Objections to
Environment Agency environmental permit application
EPR/BB3300XG/V007
(Horse Hill Developments Ltd at Horse Hill RH6 0RB)

David Smythe
(Emeritus Professor of Geophysics, University of Glasgow)

15 May 2021

Fig. 2

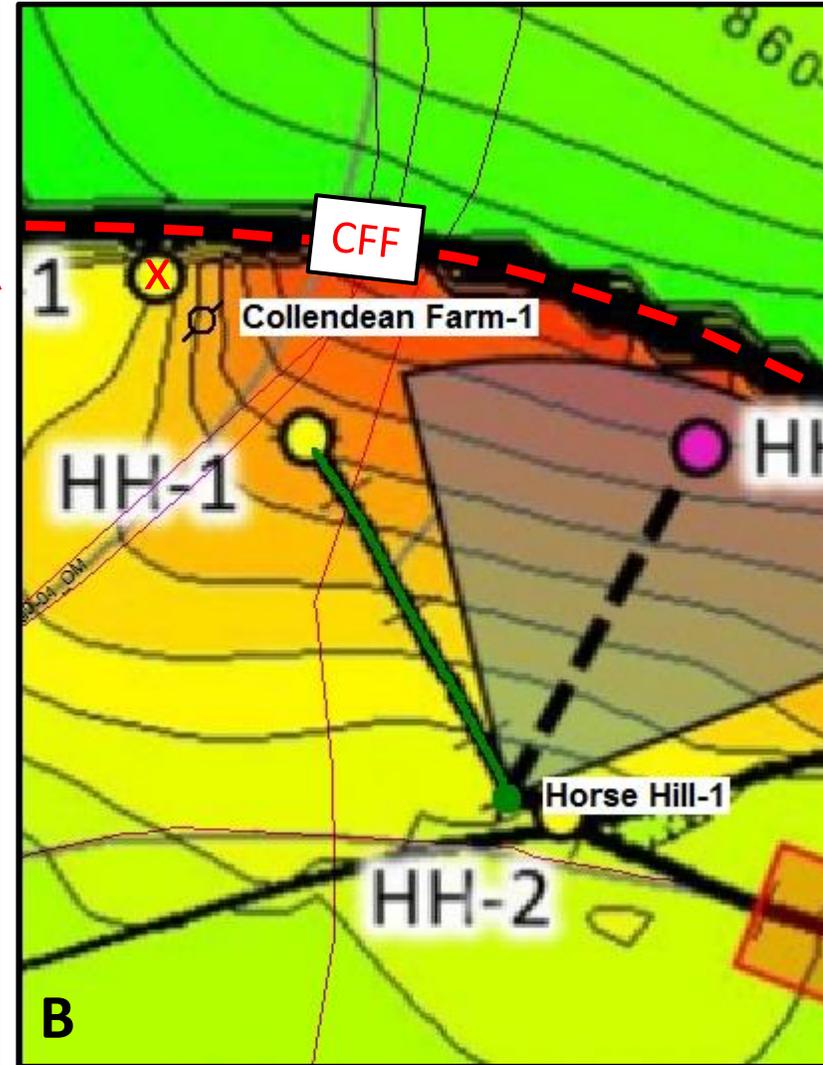
Figure 2A shows a detail of the Top Great Oolite depth structure map, submitted in application by HHDL in May 2019. The match of the digital seismic overlay (thin red lines) to the underlying colour image suggests an error of under 10 m in the registration of the image within the Kingdom v8.8 seismic interpretation package that I use for this study. However, the well locations are in error. CF-1 (yellow disc with red x) is about 130 m NW of its labelled correct location, which lies on the Collendean Farm Fault, in this interpretation.

HHDL has revised its geological interpretation since 2019. A detail of the Top Portland structure map is shown in Figure 2B. The scale and area of the two side-by-side maps in Figure 2 is identical. It can be seen that the location of CF-1 has been moved slightly SE (red x on yellow disc), and

now lies on the correct, southerly upthrown side of the Collendean Farm Fault. But it still lies about 90 m too far to the NW of the correct location.

Continuing error in location of Collendean Farm-1

Erroneous positions are marked by an **x**. The Collendean Farm Fault is highlighted by a red dashed line (CFF)

- A. Collendean Farm-1 (yellow disc) is shown by UKOG (Top Great Oolite map, 2019) about 130 m NW of its correct location as shown by the 'plugged and abandoned' well symbol. The well is positioned on the downthrown side of the Collendean Farm Fault (CFF). The surface location of Horse Hill-1 (yellow disc) is too far SE by about 100 m.
- B. The well location error has been reduced to about 90 m (Top Portland map, HDDL 2021, red x on yellow disc). The well now lies on the correct (southern, upthrown) side of the fault. The Horse Hill-1 surface and bottom hole locations are now correct (my green line).

Fig. 3

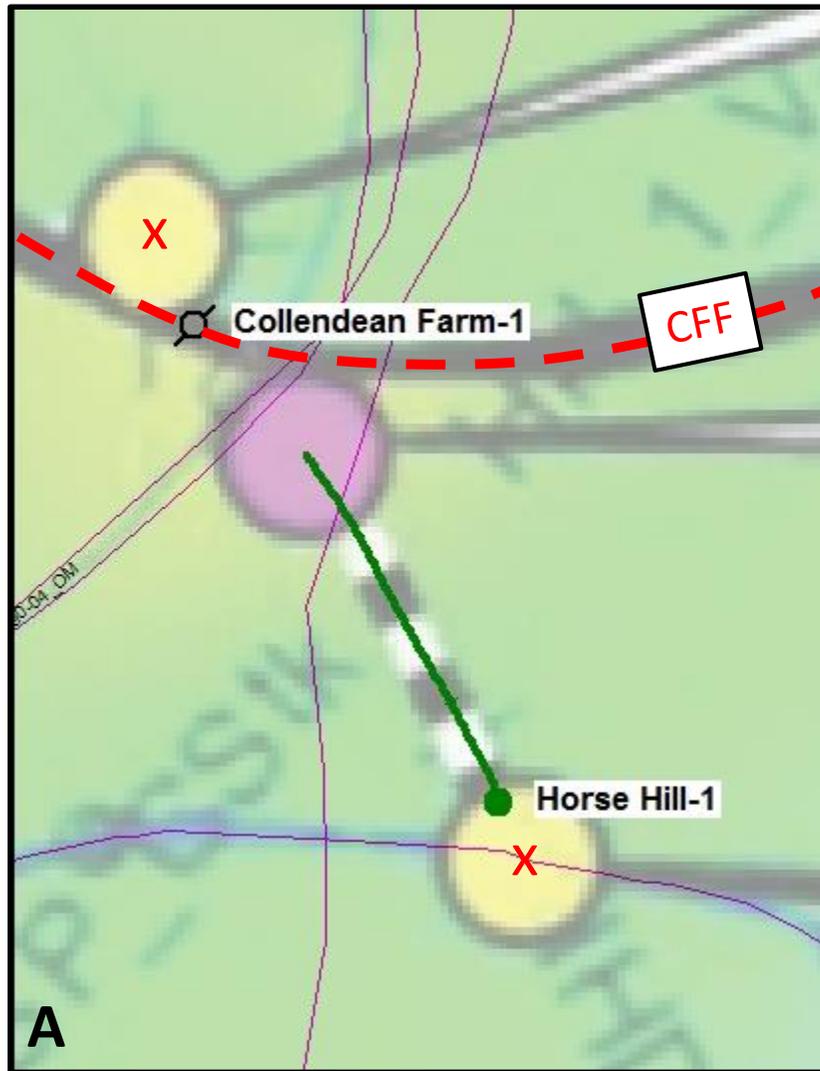
The correct location, as given by Esso in its composite well log header, is also shown in Figure 3, labelled 'CF-1 Esso BNG' (BNG = British National Grid). It is situated in a large field, which I have personally viewed from the road to the east (inset photo). In contrast, all the 2019 UKOG/HHDL and earlier Magellan maps place the well in a stream in the vale (or dean, hence the name Collendean) to the NW. This is a highly unlikely location, given that the stream was there in the 1960s when the well was drilled (Figure 3 inset) and has, indeed, existed for least 100 years, as shown by archived OS maps. The current 'HHDL 2021' location now puts the well south of the stream, but beyond a hedge to the SE, and would therefore have been inaccessible by vehicles arriving from the road (unless a temporary gap had been made in the hedge).

The composite log header for the well gives a ground elevation of 263.6 ft (80.3 m). The Esso BNG location elevation is 81.2 m, from the DTM (OS 50 cm digital terrain model), whereas an 80.3 m elevation is to be found 15 m to the north. We do not know how the Esso elevation was derived. In the 1960s it could have been from interpolating contours on a 6" to the mile (1: 10,560 scale) OS map, or by surveying in from a benchmark on Collendean Lane. Matching the elevation, it can be concluded that the Esso location is accurate to 10 m or so.

However, the elevation of the current HHDL location is only 76.6 m, and that of the previous HHDL position in the stream is 74.6 m. So the current HHDL location is 4.8 m lower than Esso's elevation, which is unlikely to be correct. The HHDL location is 95 m NW of the correct Esso location. Such an error can arise from a wrong datum being applied.

Erroneous location of CF-1 by UKOG (2019) in a stream, and HHDL's revised location in 2021. The upper right inset shows the OS map from the 1960s, demonstrating that the stream existed then. Both the incorrect locations are beyond a hedgerow, so access would have been difficult. The correct location, as defined by the operator Esso in 1964, is shown, specified in British National Grid (BNG) coordinates. It lies in the large field (photo), viewed looking west from Collendean Lane.

Fig. 4

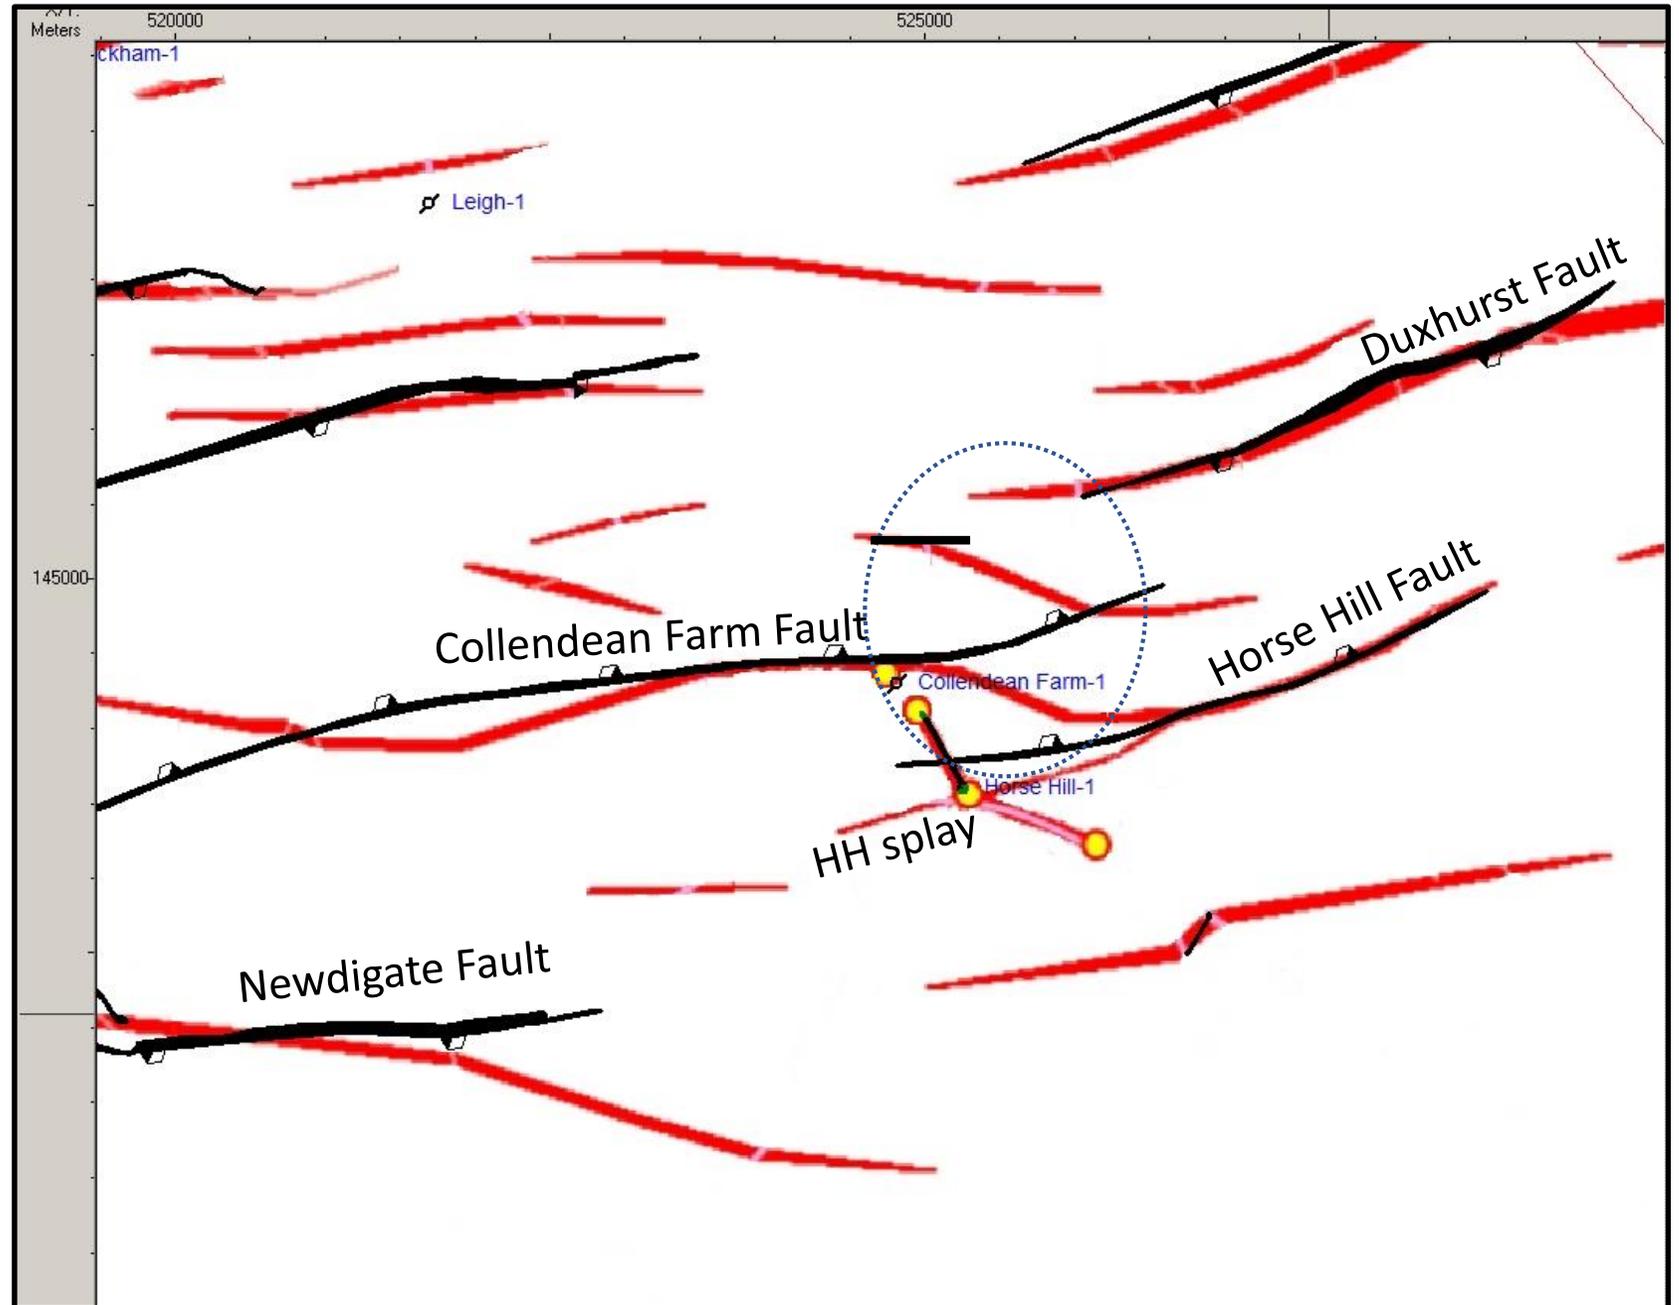
The errors in mapping of the Collendean - Horse Hill area go back to 2009. But after HH-1 was drilled in 2014, HHDL/UKOG merely made minor cosmetic alterations to the structure maps. The current interpretation, by HHDL, is shown by the red faults in Figure 4 at the Top Portland horizon.

HHDL has partially corrected the location of Collendean Farm-1, and now places it on the upthrown (south) side of the Collendean Farm Fault, but persists in its mapping of a single main fault, shown in red, running E-W through the centre of Figure 4. This single fault (on some HHDL maps labelled the Horse Hill Fault) corresponds approximately to my Collendean Farm Fault in the west, and to my *en echelon* Horse Hill Fault in the east (my black faults in Figure 4). Both these faults have a downthrow to the north.

My interpretation of the faults in the Brockham – Horse Hill – Newdigate area depicts a neat pattern of *en echelon* faults trending ENE-WSW. Outside of the Horse Hill – Collendean Farm locality it generally matches that of HHDL and earlier interpretations, including those of the oil companies which were active in the 1980s, as well as of the BGS. But HHDL's interpretation just north of Horse Hill shows two major faults abruptly swinging into an ESE trend, as highlighted by the ellipse in Figure 4.

Comparison of HHDL mapping of faults at Top Portland level (red) with mine (black). The contentious area of interpretation, where HHDL shows faults trending WNW-ESE, is highlighted by the dotted ellipse.

Figure 5.

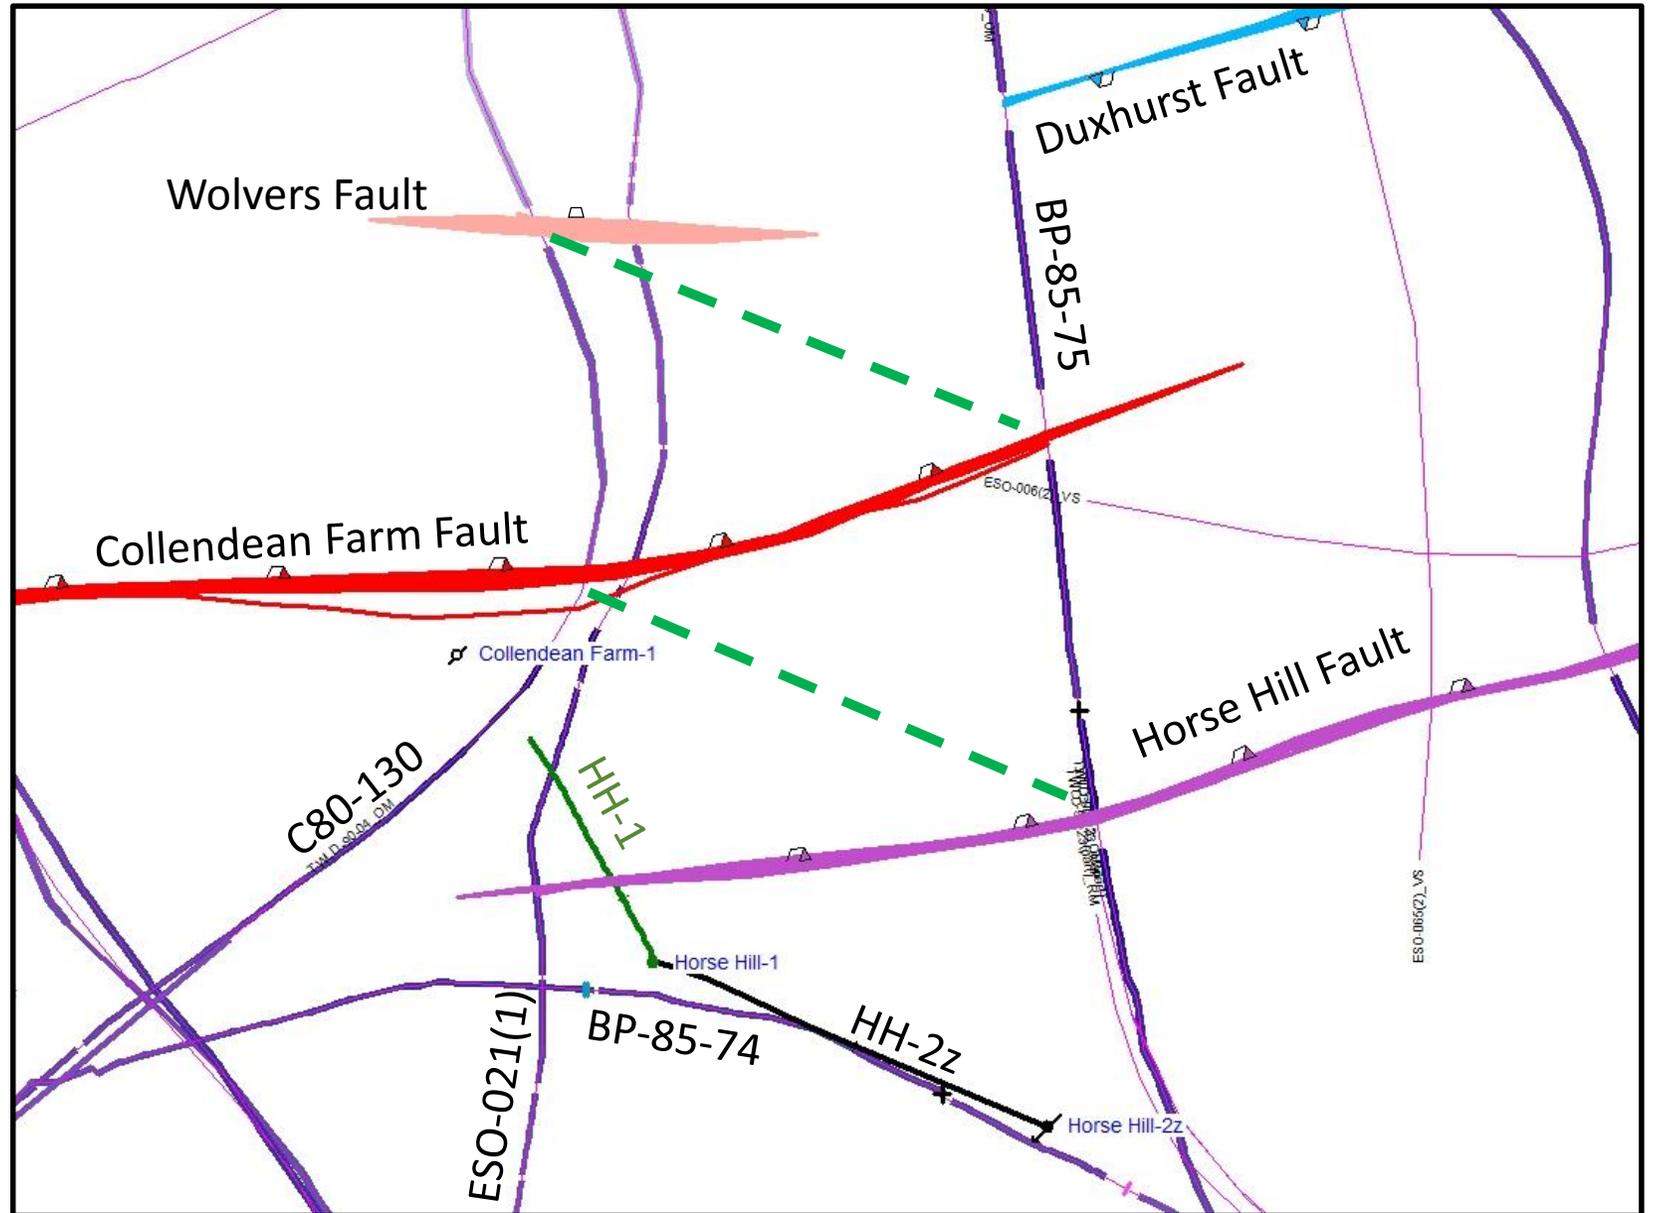
It might be argued that the HHDL mapping is a viable alternative interpretation. However its interpretation is untenable, as is demonstrated in the more detailed map of Figure 5. In this map my versions of the faults are coloured from north to south in blue, salmon, red and lilac. Going in an easterly direction, HHDL has mistakenly correlated the Wolver Fault to the Collendean Farm Fault, and the Collendean Farm Fault to the Horse Hill Fault (dashed green lines).

HHDL's error arose in part because it has not used the old Esso seismic line ESO-021(1), and relies only on the north-south lines C80-130 and BP-85-75. But the old Esso line confirms the local E-W trend of the Wolver and Collendean Farm Faults, showing that there is no local ESE trend, as would be required if the green dashed line correlations were valid. In addition, ESO-021(1) proves the existence of the continuation of the Horse Hill Fault from east to west through HH-1.

Mis-correlation of faults by HHDL

Going in an easterly direction, HHDL has correlated the Wolverers Fault to the Collendean Farm Fault, and the Collendean Farm Fault to the Horse Hill Fault (dashed green lines).

HHDL did not use the old seismic line ESO-021(1). This line confirms the E-W trend of the Wolverers and Collendean Farm Faults, and also proves the existence of the continuation of the Horse Hill Fault from east to west through HH-1.

Fig. 7

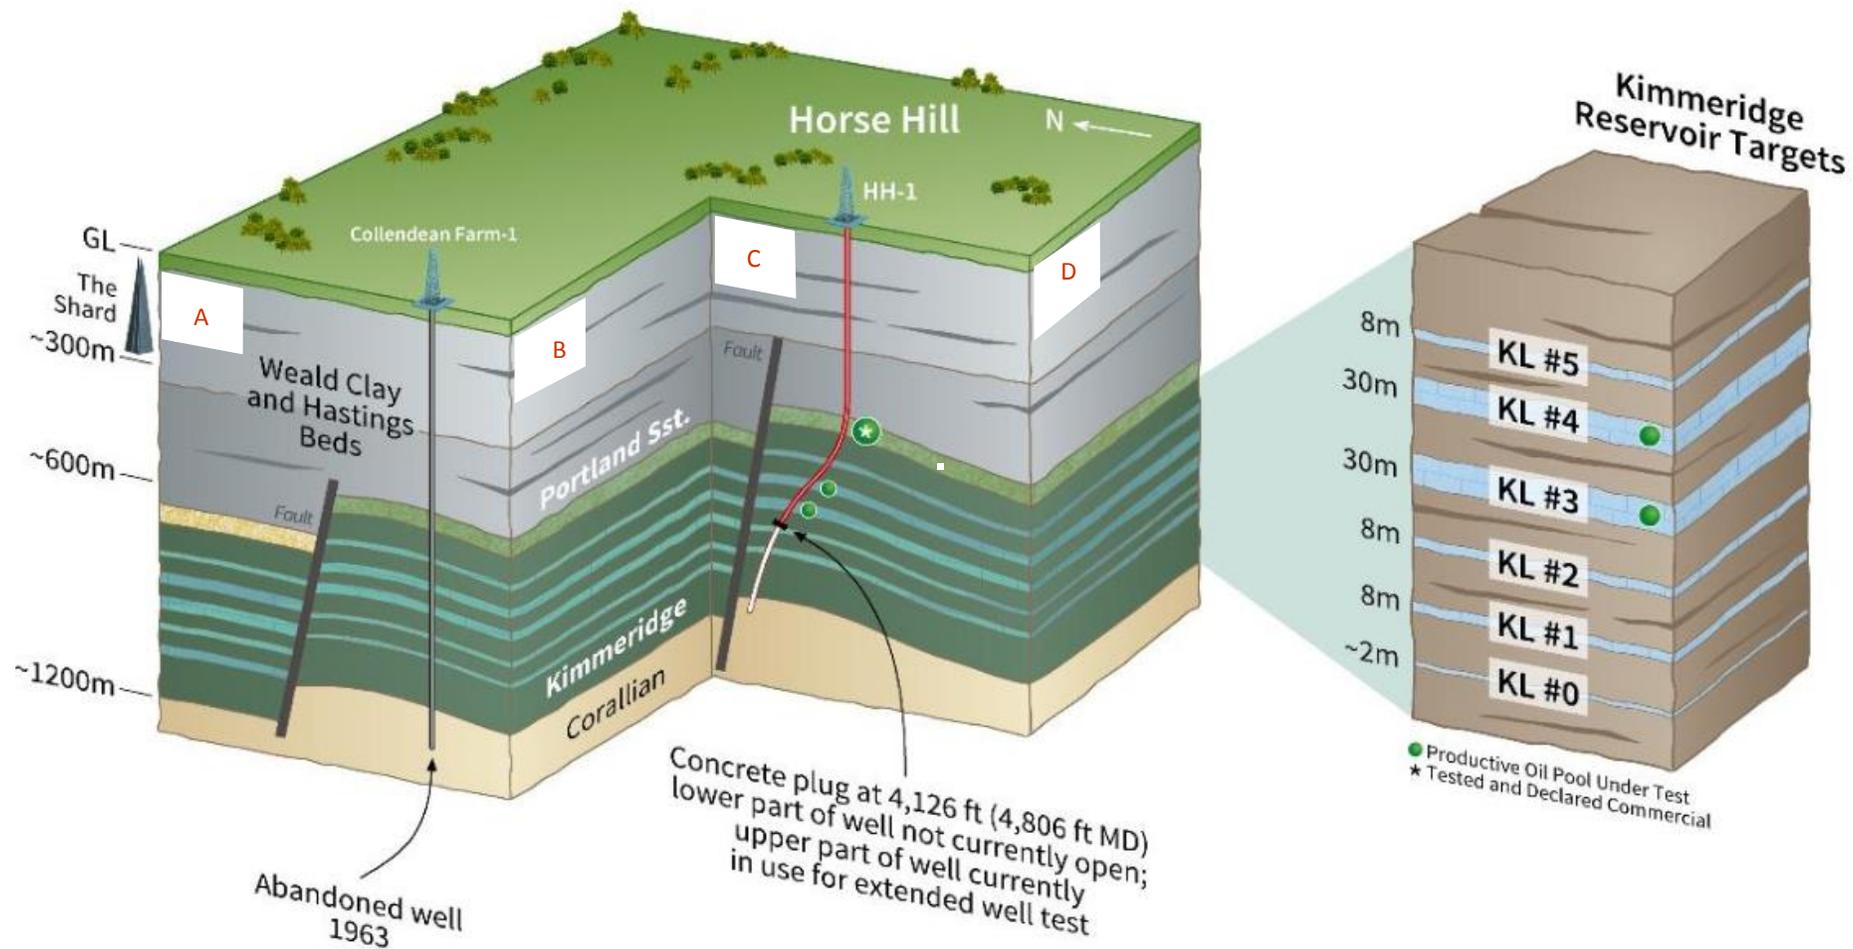
Instead of submitting the necessary detailed structural geology maps, HHDL in 2019 saw fit to supply merely a couple of cartoon perspective views of the geology and the proposed development drilling. These cartoons have not been modified or updated for the current application by HHDL. Figure 7 shows the first of these. It purports to be a perspective or isometric view of the geology, with the two existing wells shown in the N-S vertical faces, here labelled A and C, respectively. East-west face B shows no fault. Referring to Figure 8, this absence implies that there are two separate faults, conforming to my separate *en echelon* Collendean Farm and Horse Hill Faults, respectively. But if the HHDL interpretation of the Top Portland Sandstone structure shown in Figure 4 is correct, there should be a unique fault (red dashed line) which also has to cut face B.

This cartoon implies two separate faults, because if there were only one fault it should intersect the south-facing vertical section B.
